STAFF RECOMMENDATION

**1200 Seventh Avenue N, 1204 Seventh Avenue N, 1206 Seventh Avenue N, 604
Madison Street, 1201 Sixth Avenue N, 1205 Sixth Avenue N, 1207 Sixth Avenue N
June 15, 2016**

Application: New construction-infill

Description of Project: This application is for a final SP (Specific Plan) review to construct a mixed-use development on what are currently seven parcels along Sixth and Seventh Avenues North and Madison Street. In May 2015, the Commission approved the bulk, height, massing, roof form, and site layout for the project as part of a preliminary SP review. The SP (BL2015-1252) was approved by Council on August 10, 2015 and was effective August 14, 2015.

SHEET NO:
L1.0

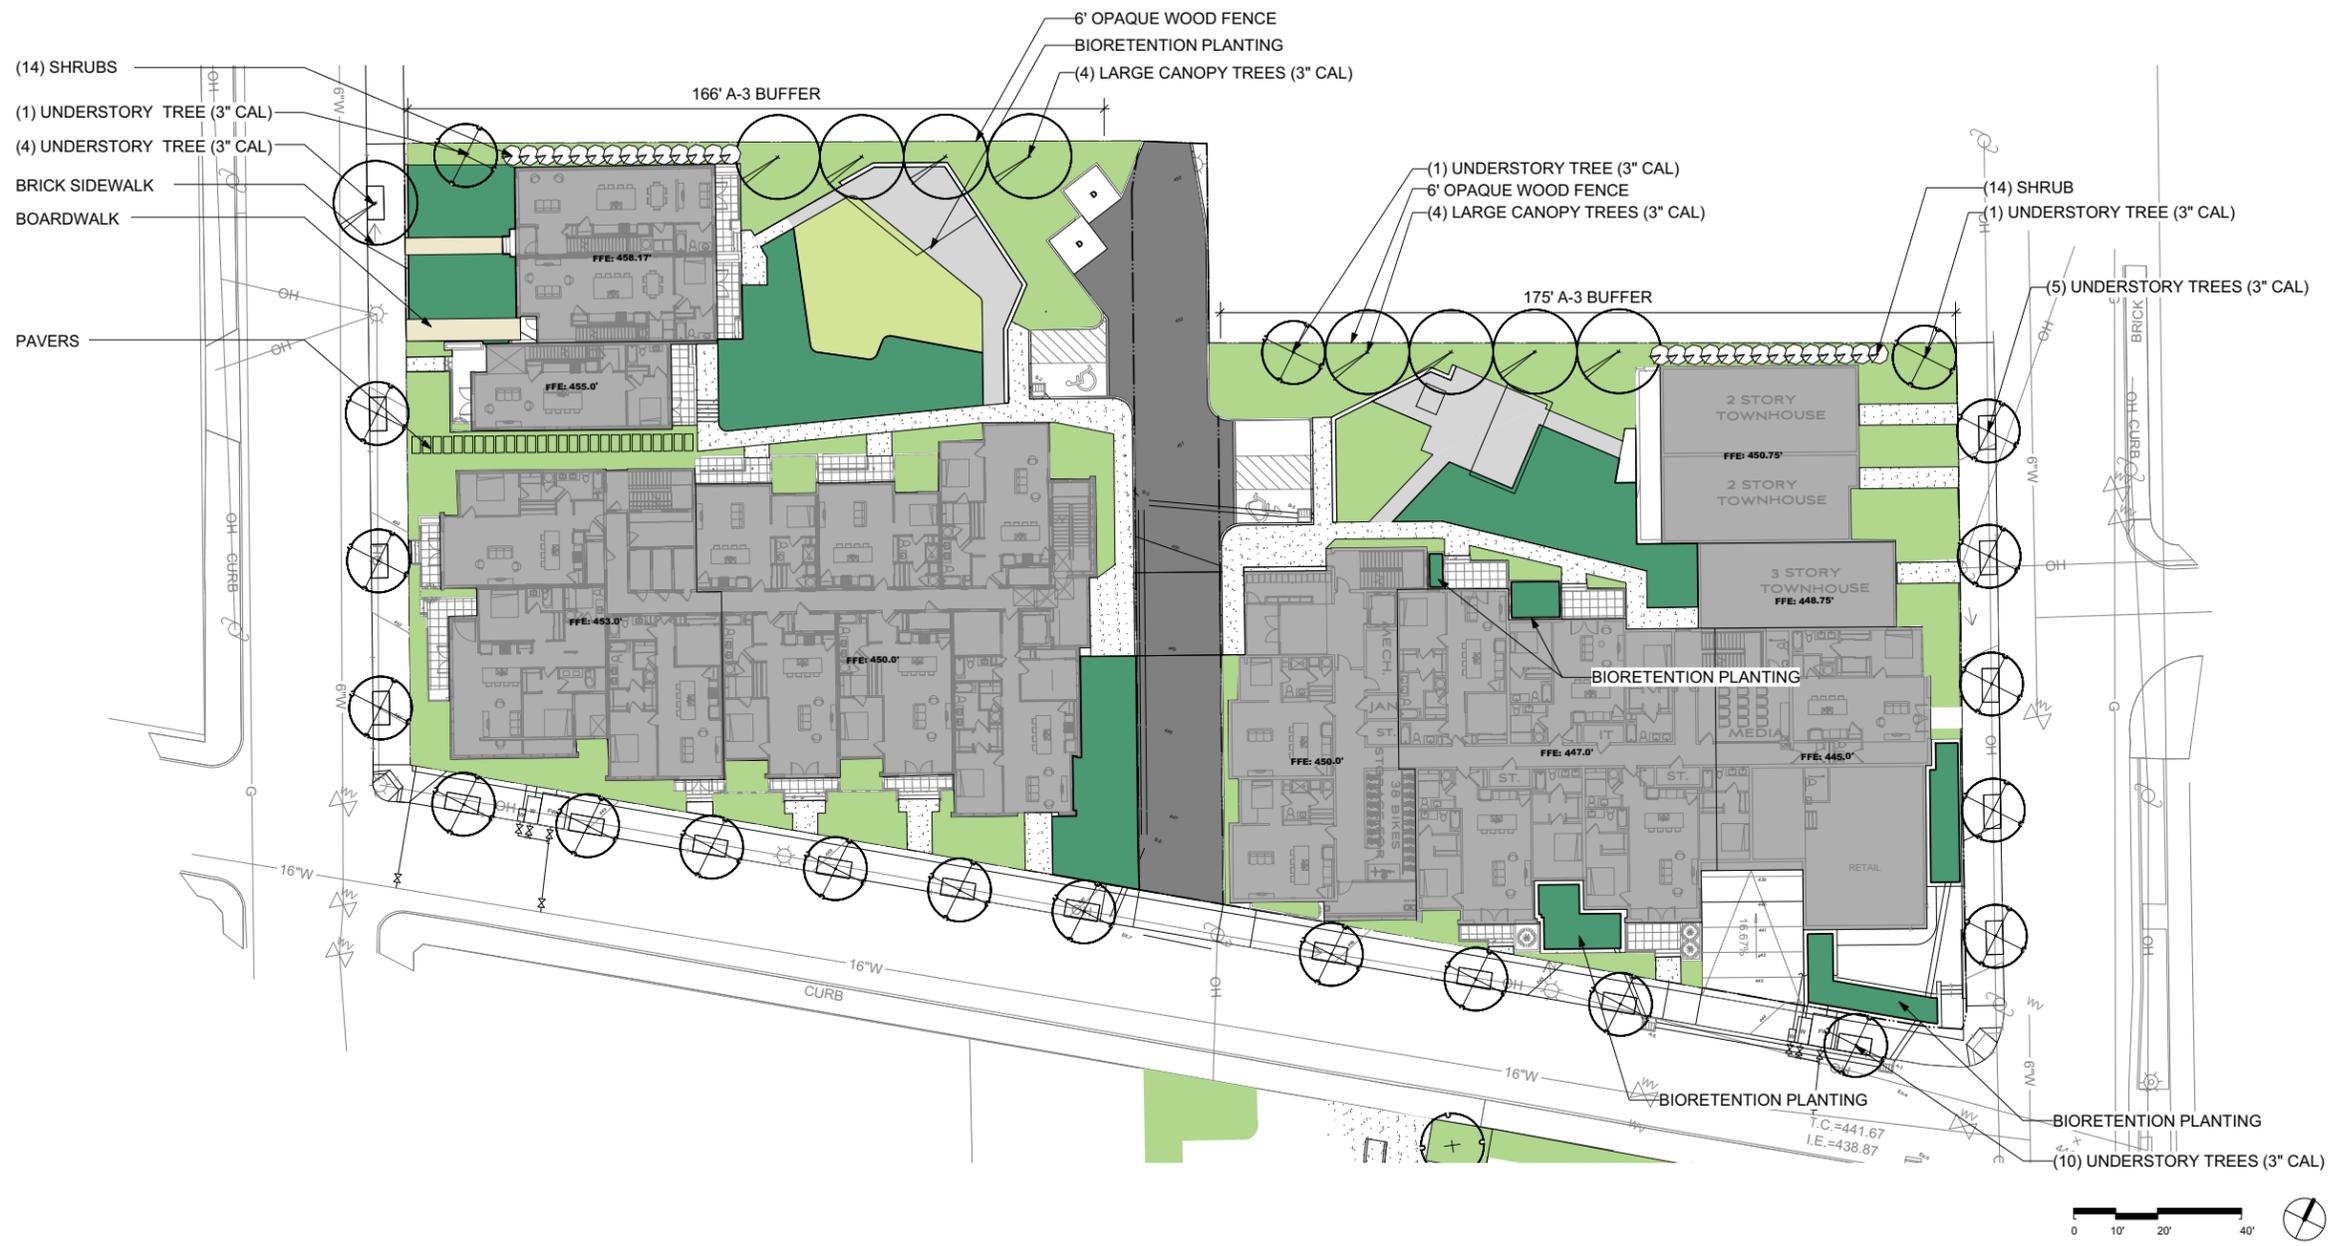
Fences: A six foot (6') wood privacy fence is planned for the development's northern property line. Staff recommends approval of the fence design. No other fencing or walls were indicated on the site plan. With the staff's approval of the fence design, staff finds that the project meets Section 5.1 of the Germantown design guidelines.
